**AGENDA**  
**CITY OF CEDAR FALLS, IOWA**  
**PLANNING AND ZONING COMMISSION MEETING**  
**WEDNESDAY, JUNE 14, 2023**  
**5:30 PM AT CITY HALL, 220 CLAY STREET**

**TO:** Planning & Zoning Commission  
**FROM:** Jaydevsinh Atodaria (JD), City Planner I  
Matthew Tolan, Civil Engineer II  
**DATE:** June 9, 2023  
**SUBJECT:** The Autumn Ridge Master Plan Amendment (MP23-002)

**REQUEST:** Request to approve revised Autumn Ridge Master Plan

**TO:** Planning & Zoning Commission  
**FROM:** Jaydevsinh Atodaria (JD), City Planner I  
 Matthew Tolan, Civil Engineer II  
**DATE:** June 9, 2023  
**SUBJECT:** The Autumn Ridge 9<sup>th</sup> and 11<sup>th</sup> Addition Preliminary Plat (PP23-001)

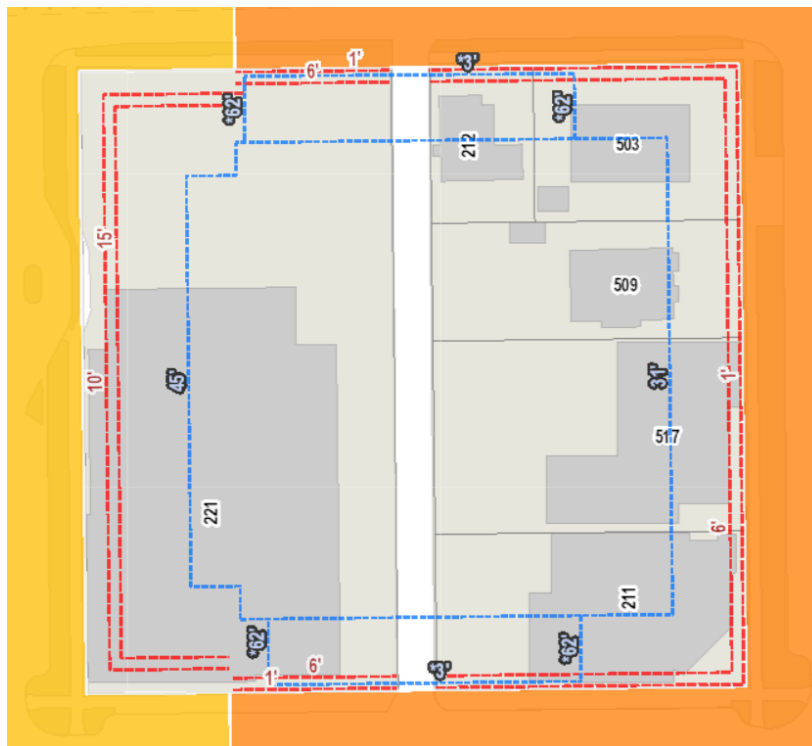
The intent of the Urban General and Storefront frontages in the Downtown Character District is to encourage buildings to be built close to the street so that street frontages are lined with buildings to support a pedestrian-friendly, mixed-use district. To achieve that goal, the regulating plan for the Downtown Character District contains a build-to line at the fronts of lots indicating where buildings should be aligned along the street. The parking setback line in the Urban General, Urban General 2, and Storefront frontages is generally about 30 feet behind the build-to line indicating where parking can be located. Along the side streets (generally the numbered streets that run perpendicular to the mid-block alleys), there is an area where parking can be placed closer to the street if it is enclosed within a building. See an excerpt from the Downtown regulating plan below with the red lines indicating the build-to area and the blue line representing the parking setback line. Parking can be located anywhere behind the blue lines.

To provide more flexibility for civic and institutional uses in the Downtown Character District, staff suggests consideration of creating a special rule that would allow parking to be located forward of the parking setback line on the regulating plan, but with certain conditions that would ensure that parking areas are buffered and screened with landscaping and trees from public sidewalks and abutting properties. The following language is provided for consideration:

# MASTER PLAN - AUTUMN RIDGE NINTH AND ELEVENTH ADDITIONS CEDAR FALLS, IOWA

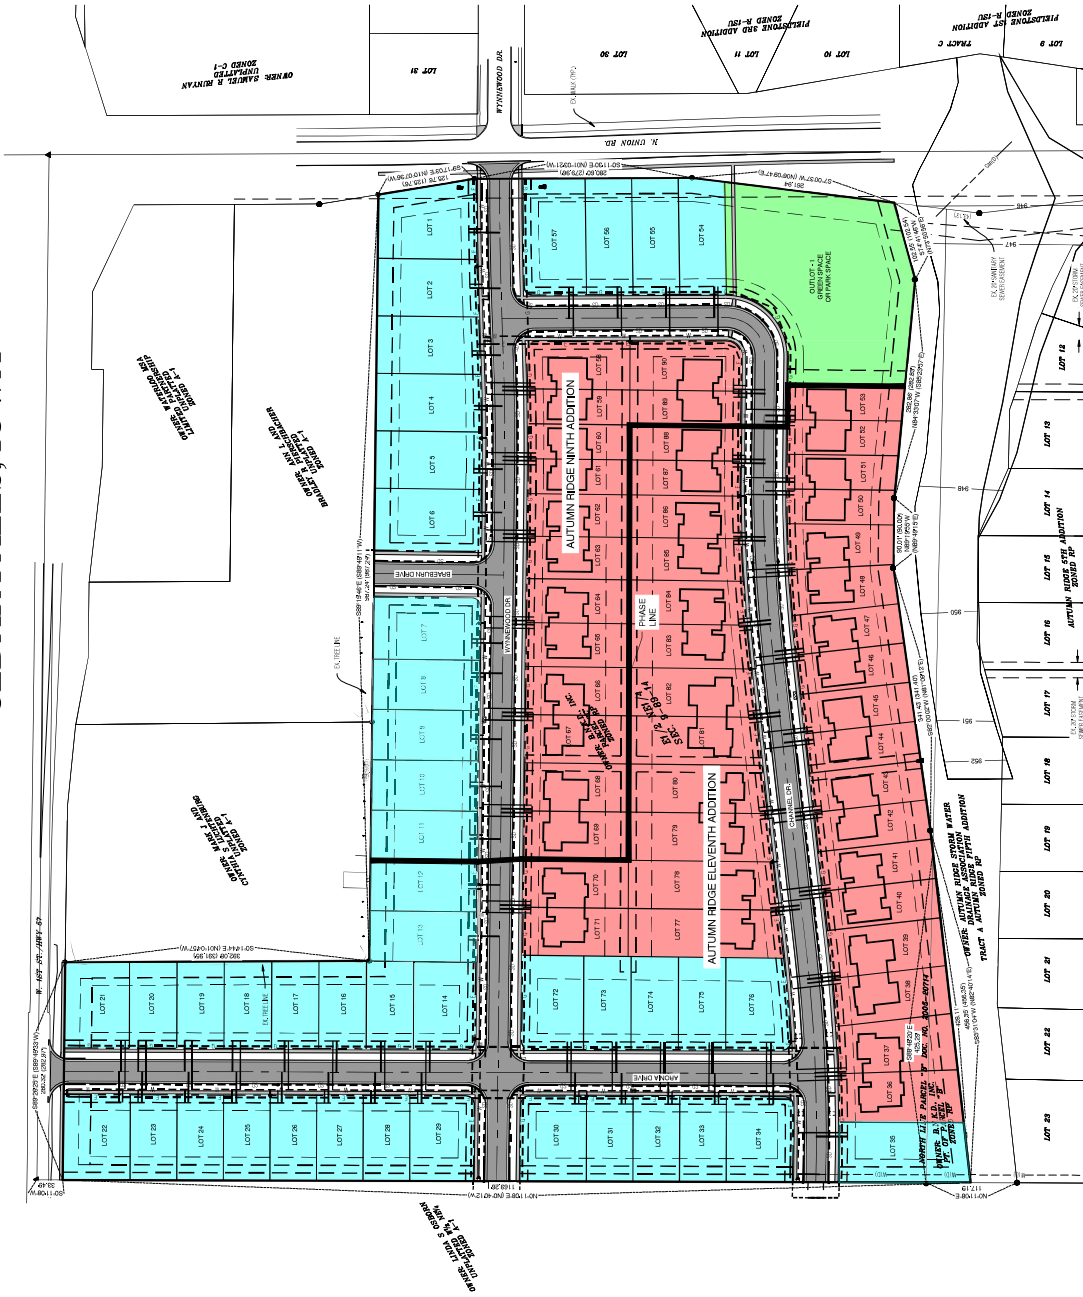
The Master Plan exhibit submitted with the current revised application highlights the two remaining phases (9<sup>th</sup> and 11<sup>th</sup>) in the subdivision in context with the rest of the development in Autumn Ridge. The updated RP master plan proposed by the developer is described below, with areas of change from the original plan highlighted and staff recommendations noted.

this concern. The developer has indicated that they would like to move forward with the proposal with the street-facing garages, but to address the issue is proposing to add a clause in the developmental procedures agreement and deed of dedication stating that all approaches and driveways in the development will be limited to maximum driveway width of 18 feet at the property line and lots narrower than 60 feet will allow a maximum two-car garage. 18 feet is the minimum width driveway for a two-car garage and allows for two standard width parking spaces behind the garage, so each unit would have at least four off-street parking spaces.

While staff is not opposed to the elimination of the wet-bottomed retention stormwater basin (lake), elimination of the shared open space and amenities entirely is not recommended. In response, developer has included Outlot 1 in the proposed master plan, which is labeled as “Green Space or Park Space.” The green space is proposed to be included in the first phase of development. This green space will need to be carefully graded and seeded to provide usable park space (more details about the proposed park space are included in the preliminary plat staff report). Staff also notes that the developer proposes a sidewalk connection to access the park space from the Union Road sidewalk, to provide easy accessibility to park space for all residents of Autumn Ridge, both north and south of the drainage way, which will need to be added in Phase 1 of the project. This sidewalk connection will require the developer to regrade the previously established Union Road drainage ditch in Right of Way. Additional grading will be done to tie the southerly limit of the park space into the existing stormwater detention facility.

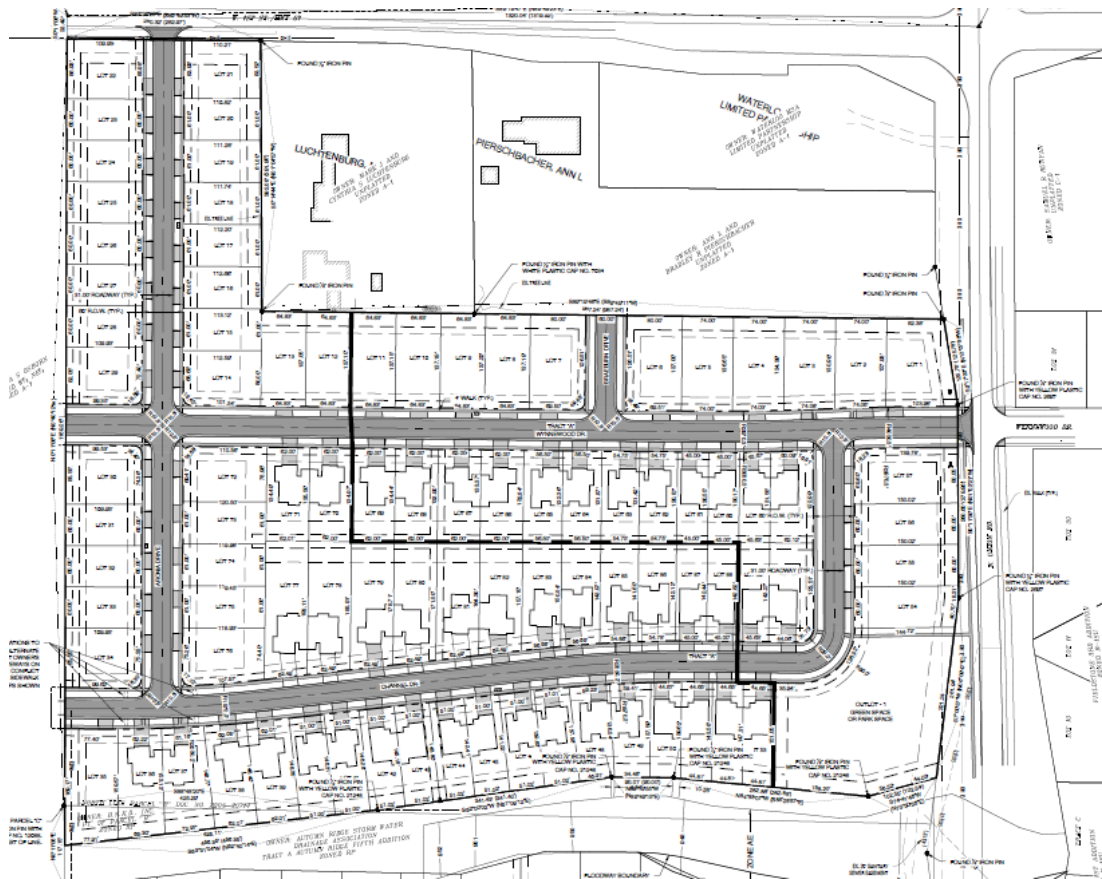
City staff finds that the setbacks will be appropriate for the development being similar to setback requirements for single family dwellings in the R-4 District. City staff notes that the required setbacks should be noted on the plat and in the deed of dedication.

City staff notes that the bi-attached units are all proposed with front-loaded garages. As described in the staff report for the RP Master Plan amendment, staff is concerned about the effect that so many driveways and curb cuts will have on the livability of the neighborhood, as there will be little room for on-street parking, street trees, or landscaped front yards. Driveway paving will cover a significant portion of the front yards and interrupt the sidewalk along the street (see driveway exhibit below).

The developer has indicated that they would like to move forward with the proposal and to address the issue of wider driveways and curb cuts, developer is proposing to add a clause in the deed of dedication stating that all driveways in the development be no more than 18 feet wide at the property line. In addition, lots narrower than 60 feet are limited to 2-car garages. For larger lots with 3-car garages, driveways can still meet the maximum 18-foot standard at the front property line if the driveway is flared out in a manner that meets the zoning code standards, so there is separation between the public sidewalk and any extended area beyond the 18-foot width. On some lots this may require the third garage stall to be setback further to maneuver, which is a common design. While staff is still concerned about this issue and the quality of the neighborhood streetscape it will produce, we are accepting of this solution.
